**Notice of Determination under Section 81(1)(a) of the
Environmental Planning and Assessment Act, 1979
Development Application No. 211/04**

**Proposed Development: Demolition of existing building and erection
Of Residential Flat Building with basement
Level carparking**

Land to be developed: 5 Commonwealth Parade, Manly

Drawing **LEVEL 2 PLAN**
 Project **Unit Development**
 5 Commonwealth Parade, Manly
 Client **Mr C Koutsos**

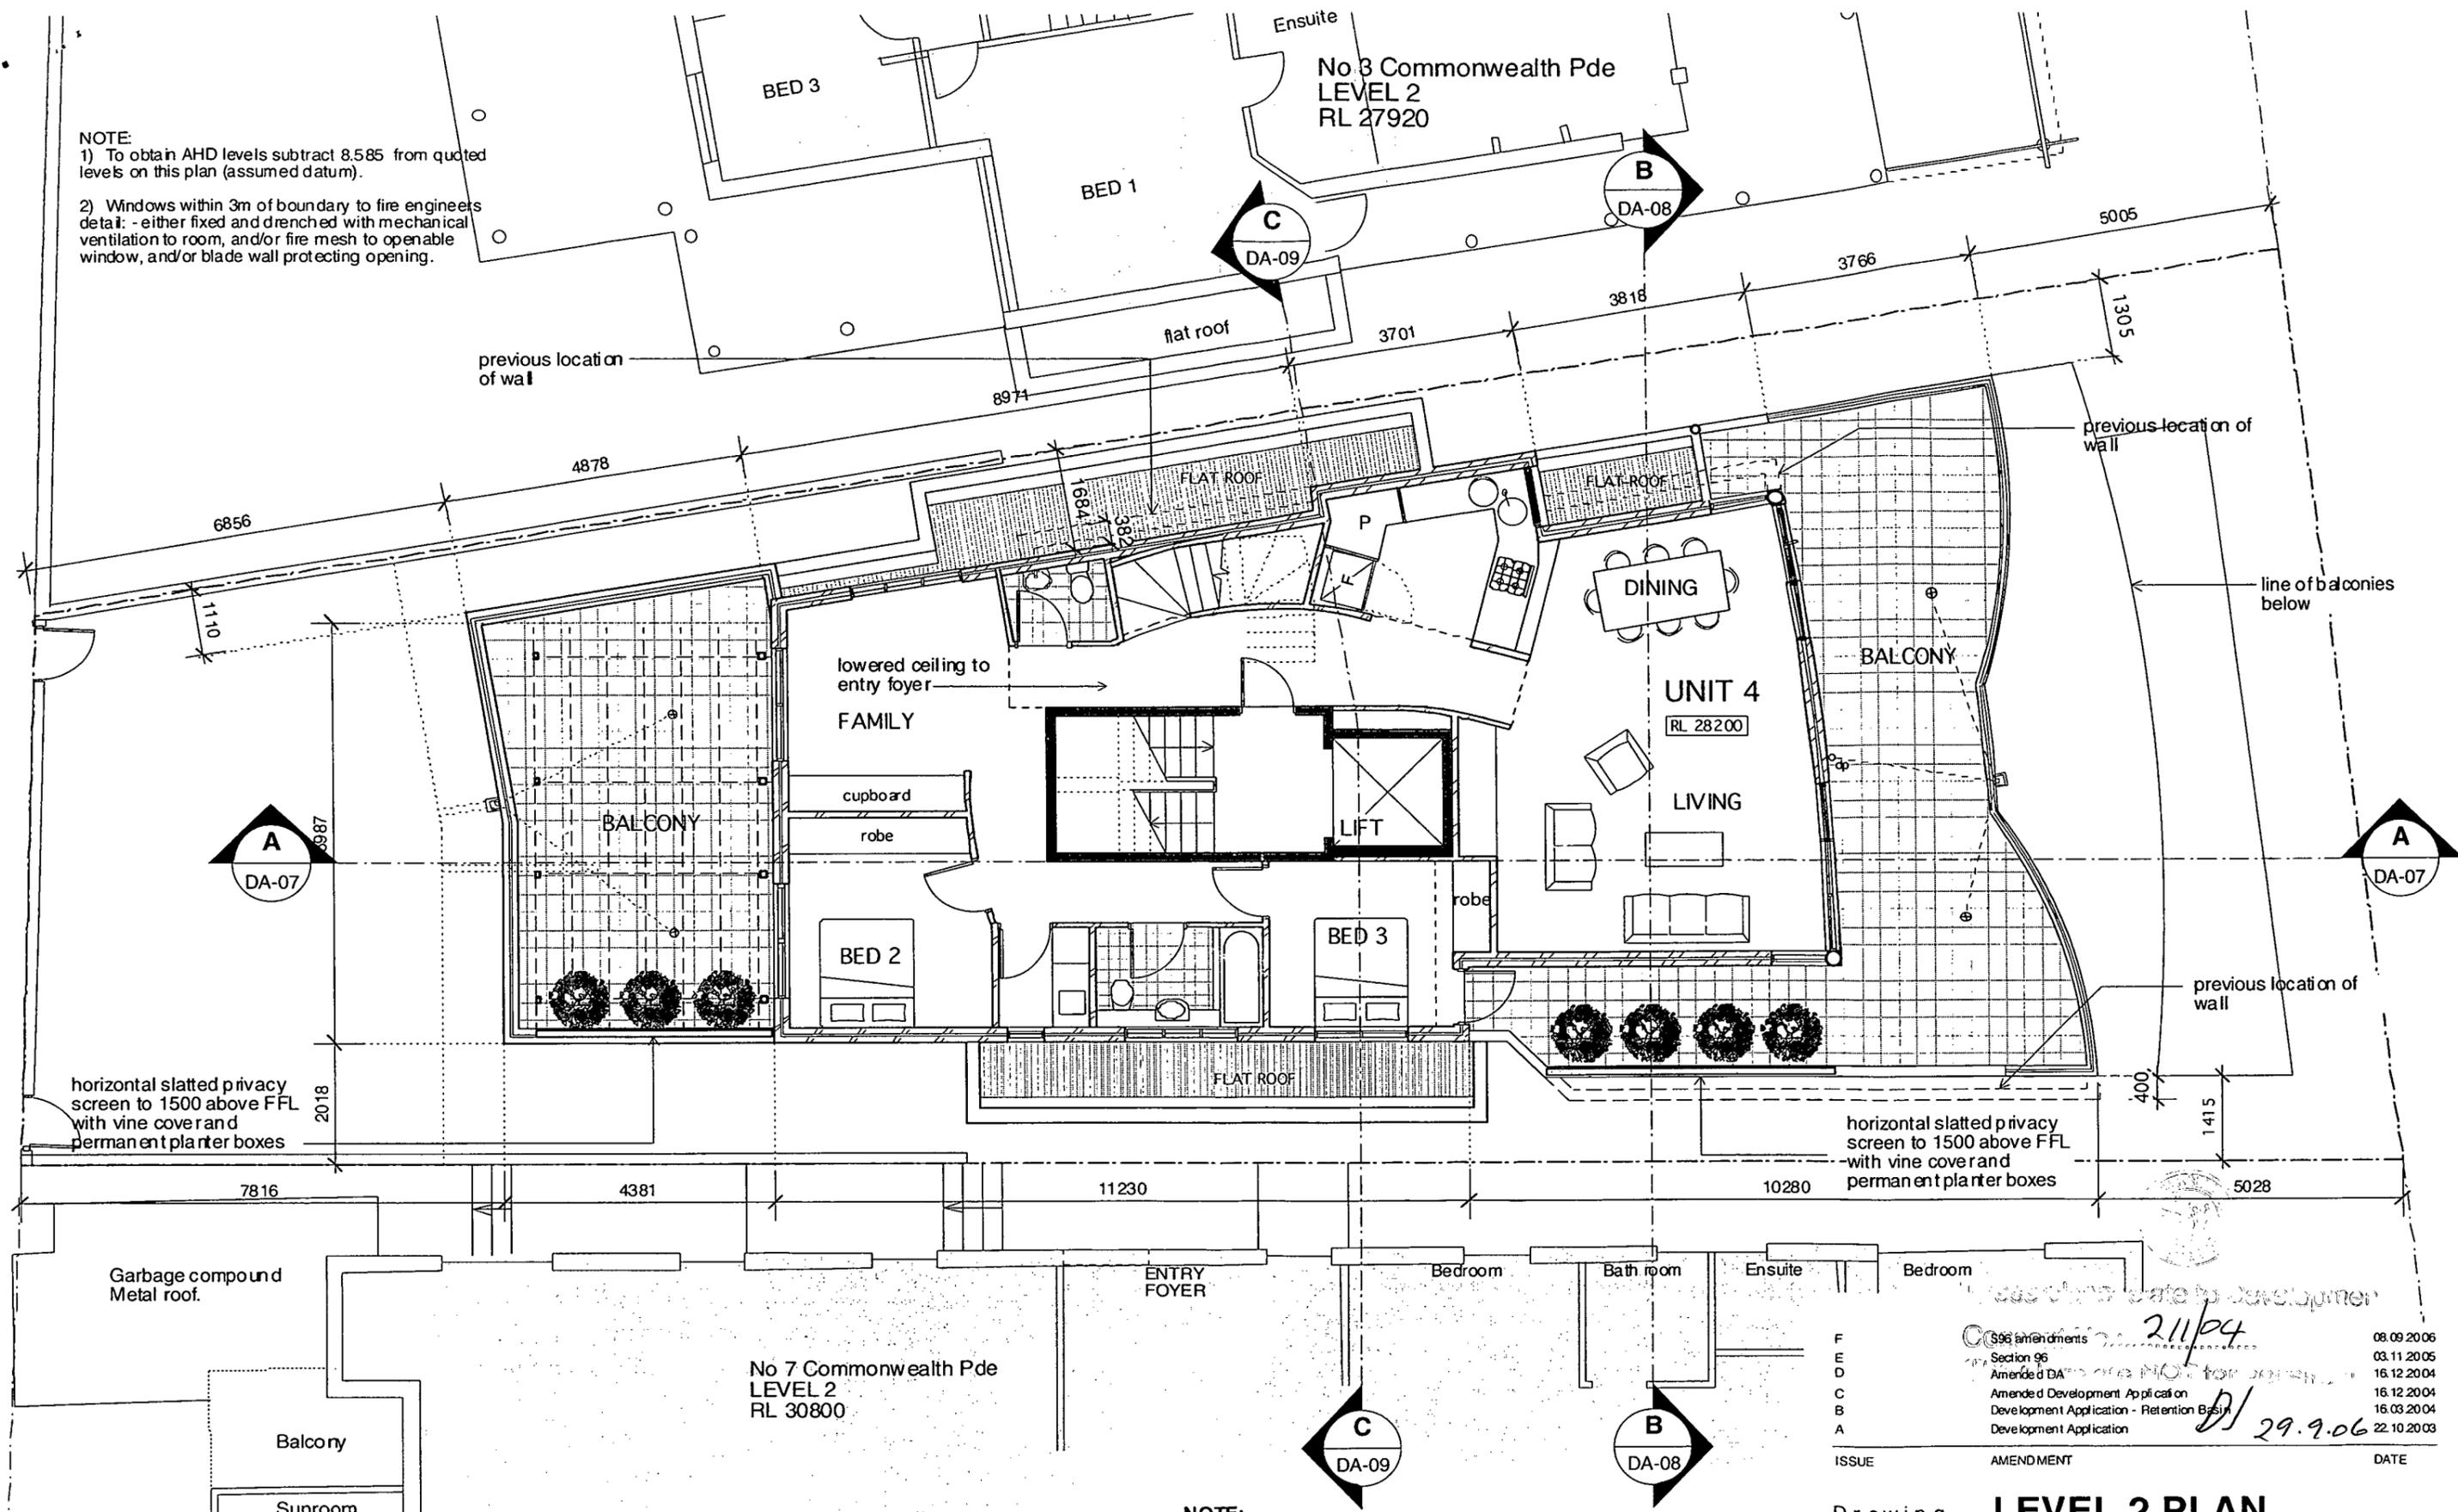
6. The northern walls of Bedrooms 2 and 3 at Level 1 are to have a maximum average height of 3.2m, including the roof structure. In this regard the modifications of the flat roof sections on the level 2 plan to a pitched or curved roof form is satisfactory.
